MFN 06-262
Supplement 4

Subject: **Modified Reactor Building/Fuel Building Truncated Model,
SER-ESB-038 Rev. 5**

**Shimizu Engineering Report SER-ESB-038, Rev. 5,
“Modified RBFB Truncated FE Model Analysis Data,”**

Project	General Electric Company ESBWR Project	Shimizu Document No.	SER-ESB-038
Title	Modified RBFB Truncated FE Model Analysis Data	Rev.	5
		Issued Date	9/22/06
		Revised Date	1/9/07

Figure C-8 Element Forces Comparison NASTRAN to ANSYS (RG FF Wall: Out-of-plane Moment [MN-m/m])

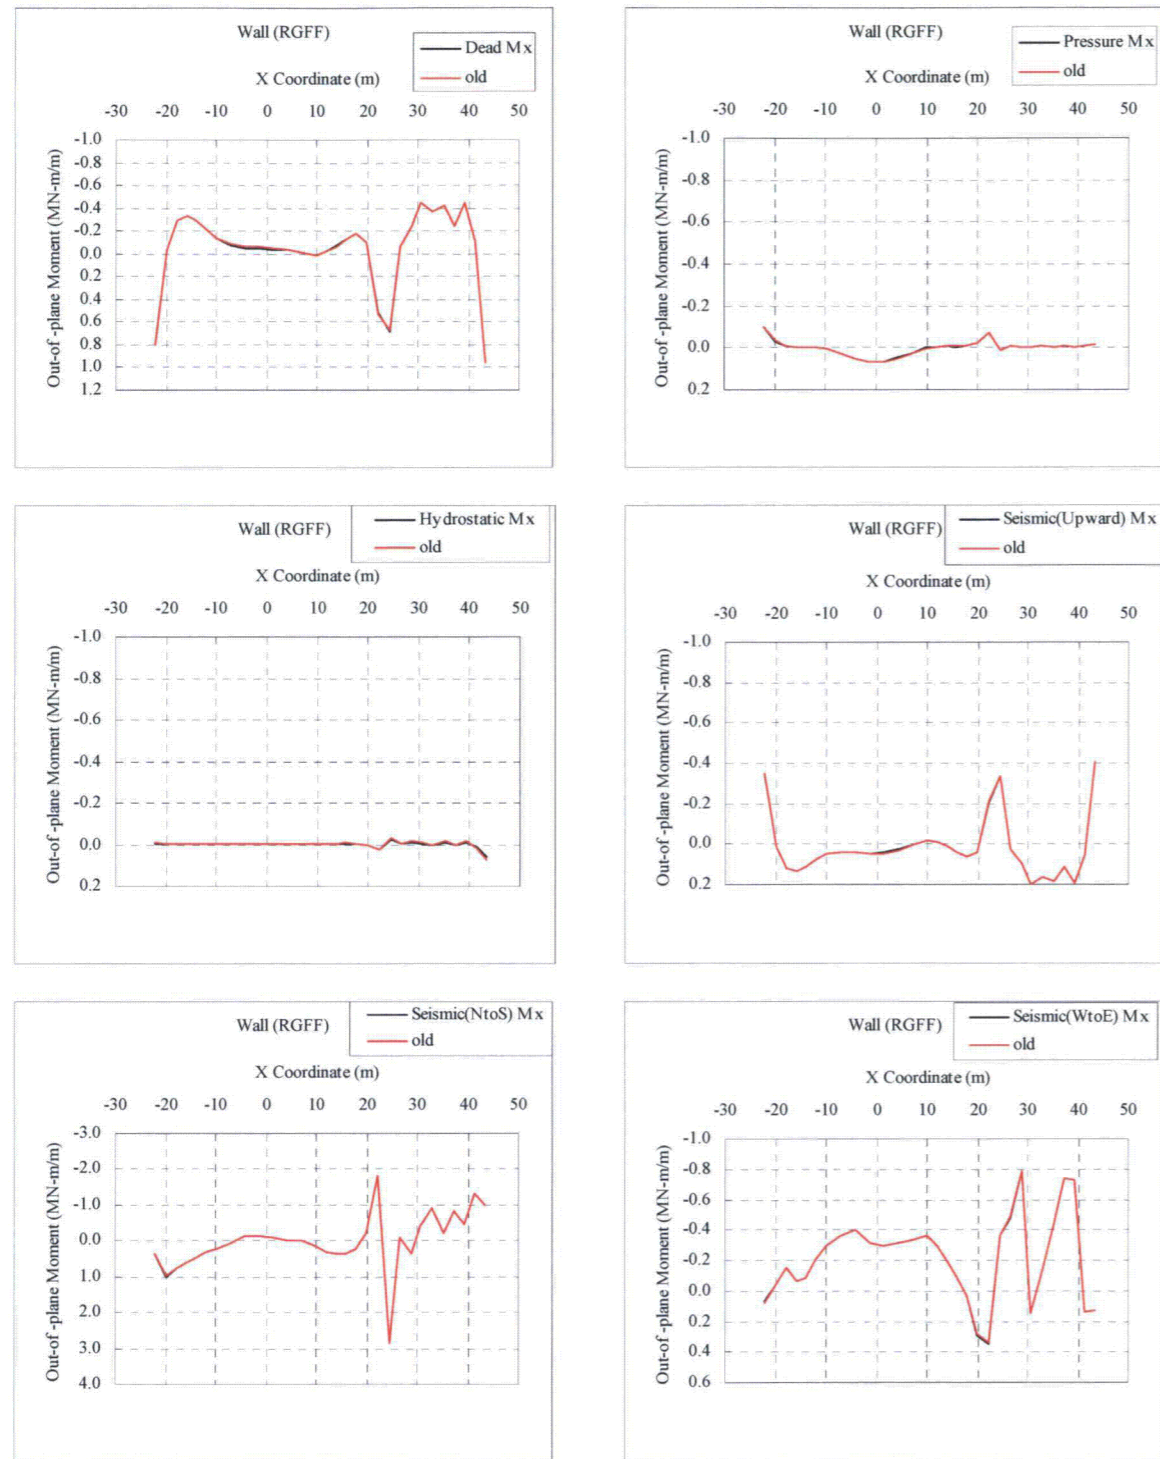
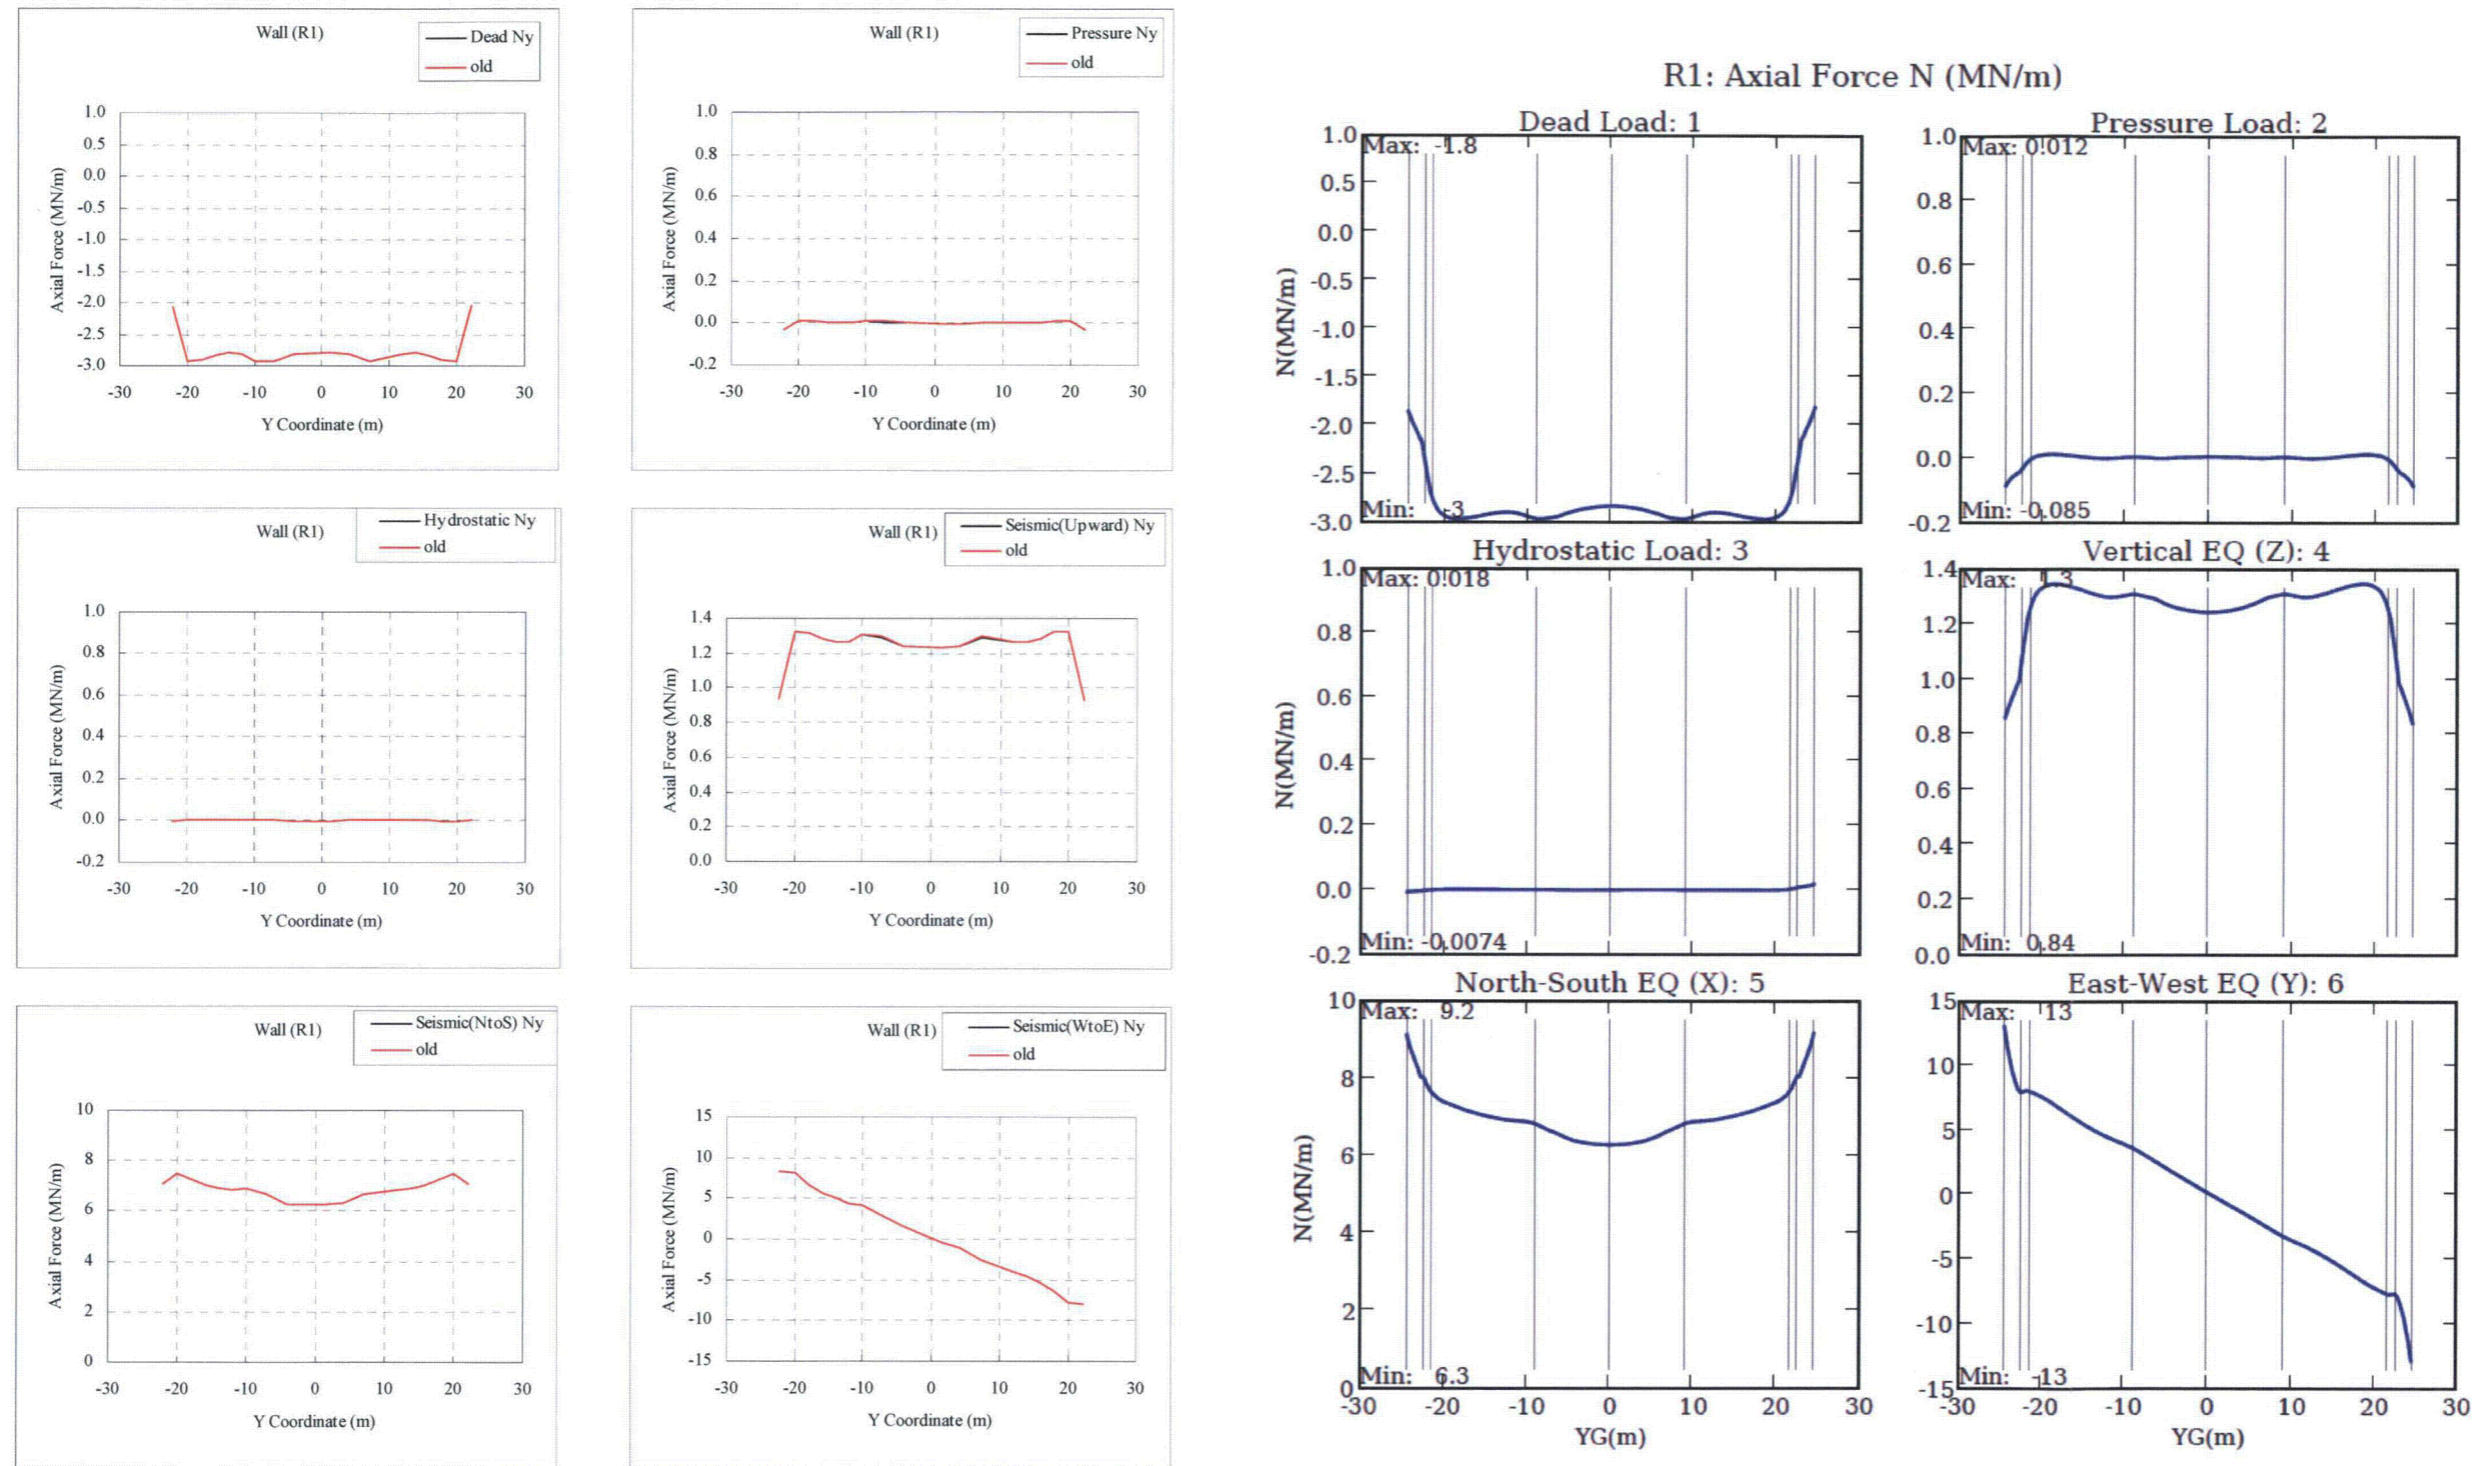
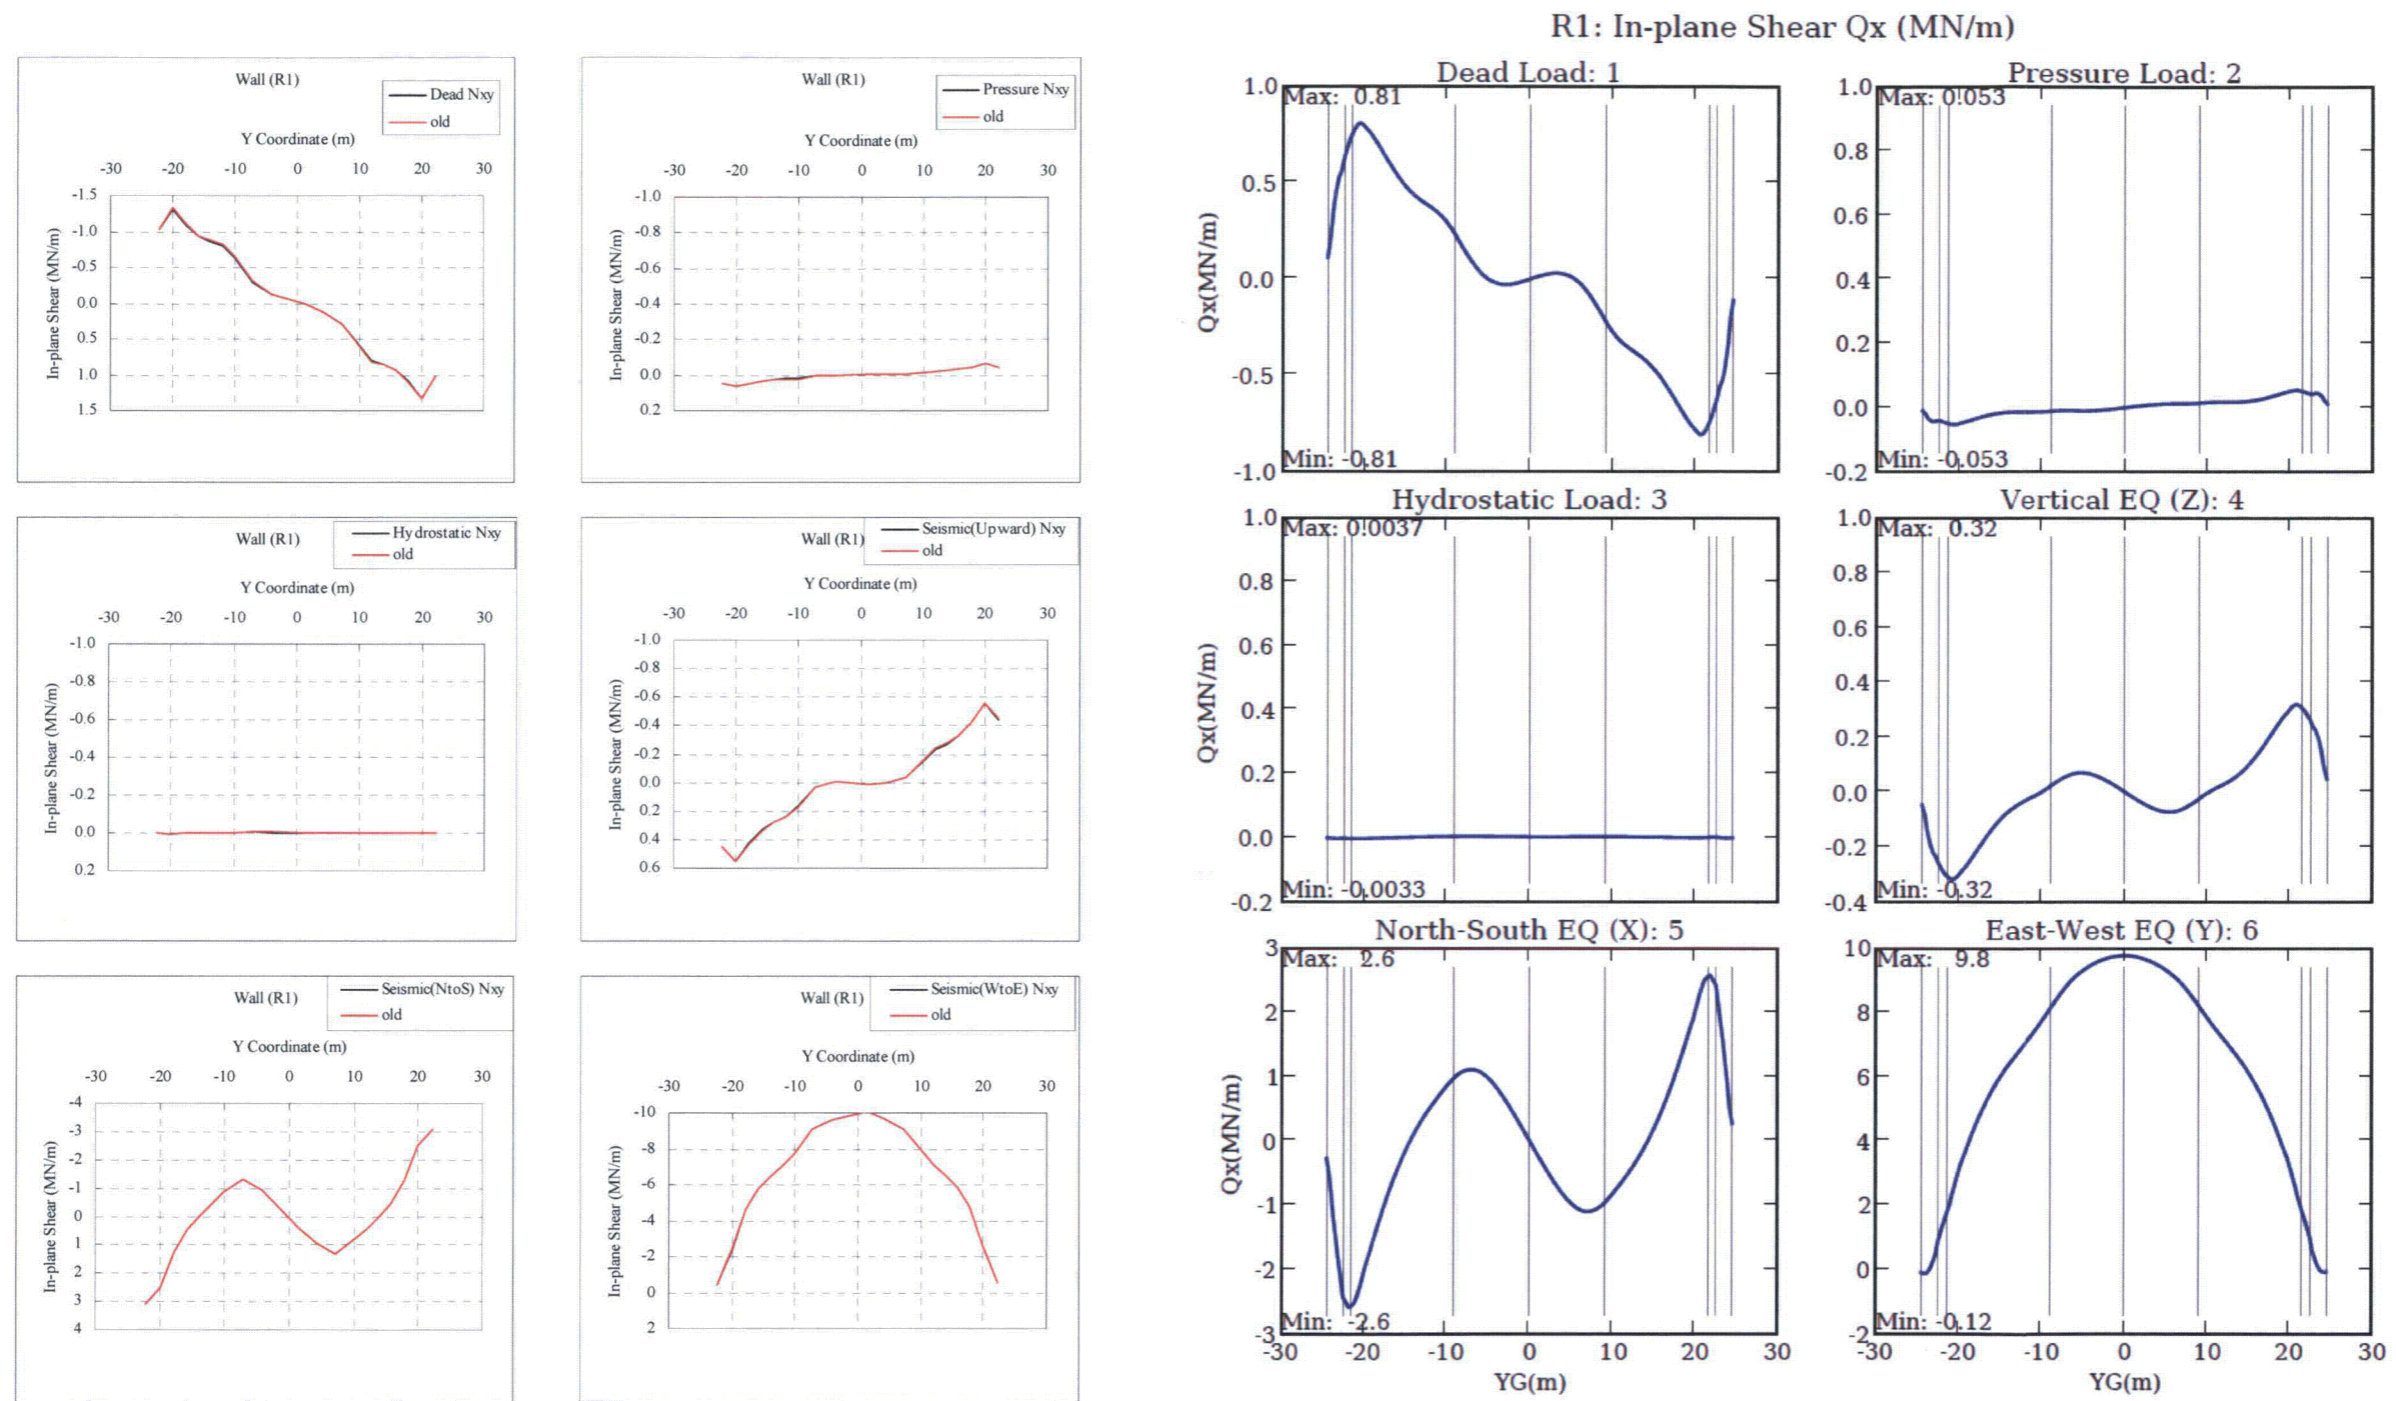
- iii) *The differences of magnitude of forces appeared on basemat inside pedestal:* The result of re-analysis using the updated model shows better agreement. In case of seismic load the magnitude of forces has to be re-compared because BNL's soil spring may not be adequate as pointed out above 3).

- iv) *The differences of magnitude of forces appeared on outer wall of Fuel Storage Pool (FSP):* For the out-of-plane shear forces and moments on RA and F3 wall located around FSP in case of Hydrostatic load, BNL's results are lower than those of GE. GE assumes the some part of differences comes from the difference of estimation levels between both models as pointed out above 8). In order to have a better understanding of the differences, GE would like to request BNL to confirm the input data for Hydrostatic load.
